MONTHLY PROGRESS REPORT

KENDALL COUNTY

NEW OFFICE BUILDING

Section 5: Architectural & Engineering Field Reports

Sprinkler Progress and Condensation

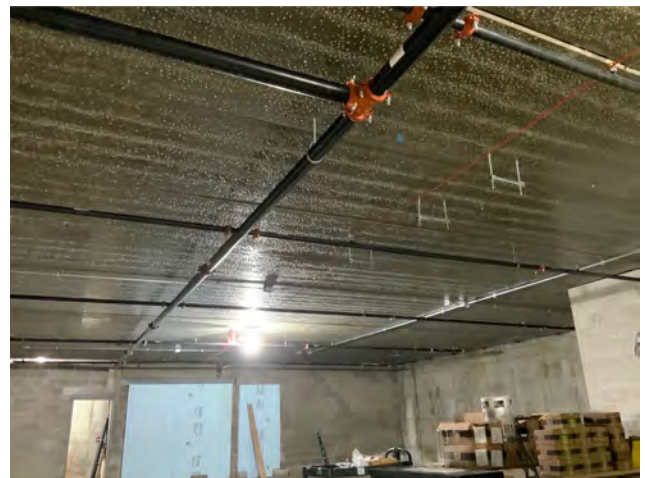
1. The bottom of the precast plank in the basement has condensation and causing puddling on the floor. As discussed with CM, heaters will be provided in next couple weeks, verify this will help eliminate the condensation.
2. Due to the condensation in the basement, verify lighting currently installed will not be damaged.

Soffits and East Side

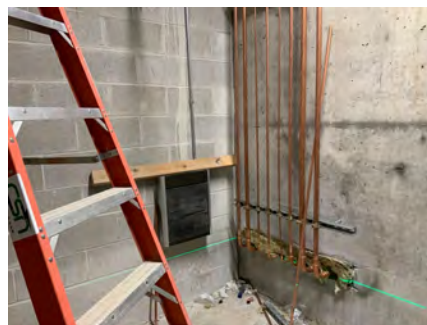
1. Any penetrations through concrete wall for equipment on the east needs to be sealed tight. Verify detail where there are multiple pipes running through the concrete wall to outdoor units.
2. On east wall of Voter Registration/ Training 103, outlets for TV appear to be 42" above floor level and will be exposed, verify if this is acceptable to the owner.
3. Minimal amount of water discovered on floor near door 104A, verify if this is related to construction crew or potential roof leak.

Conduit in Gap between CMU and Planks

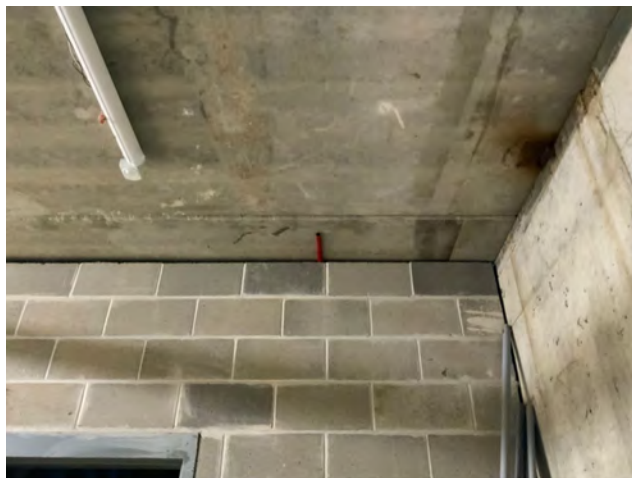
1. In the basement, there is a gap between CMU and bottom of precast planks, CCA to confirm if insulation infill is required.
2. Piping/ conduit appear to be installed in gap between CMU and precast planks. The planks may deflect and cause damage to the pipe/conduit. Relocate to avoid potential damage.
3. Coordinate future rough in walk through in field with owner to confirm electrical power/ data locations.
4. In Mech 003, the occupancy sensor appears to be slightly obstructed and so you have to walk in the middle of the space to activate. Relocate occupancy sensor to opposite side of fixture so lighting activates upon entry.
